Kawasaki Motors Corp – Safety Recall

KAWASAKI/EX650C9F/2009
KAWASAKI/EX650CAF/2010

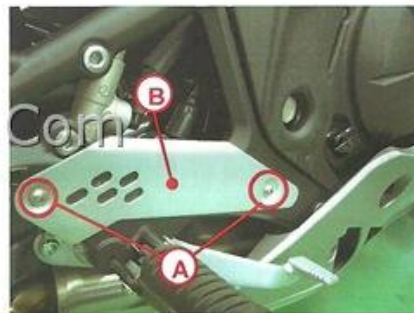
KAWASAKI IS RECALLING CERTAIN MODEL YEAR 2009 EX650C9F/FL AND MODEL YEAR 2010 EX650CAF/FL NINJA 650 MOTORCYCLES. THE RIGHT REAR PORTION OF THE LOWER COWLING CAN INTERFERE WITH THE OPERATOR'S FOOT WHILE IN THE PROCESS OF APPLYING THE REAR BRAKE.

THIS COULD DIMINISH THE OPERATOR'S CONTROL OVER BRAKE FORCE APPLICATION OR DISTRACT THE OPERATOR, CREATING THE POTENTIAL FOR A CRASH RESULTING IN INJURY OR DEATH.

DEALERS WILL INSTALL AN UPDATED FOOTREST GUARD AND FAIRING BRACKET. THIS SERVICE WILL BE PERFORMED FREE OF CHARGE.

- Install new lower fairing bracket RH (11056-0590) with new bolts (92151-1755).
Torque – lower fairing bracket bolts : 12N · m (1.2kgf · m , 106in · lb)
- Install the lower fairing RH.
Torque – lower fairing mounting bolt (M6): 8.8N · m (0.9kgf · m , 78in · lb)

- Remove the bolts [A] and the guard [B].
Scrap old guard.

- Install new guard (55020-0597) [A].
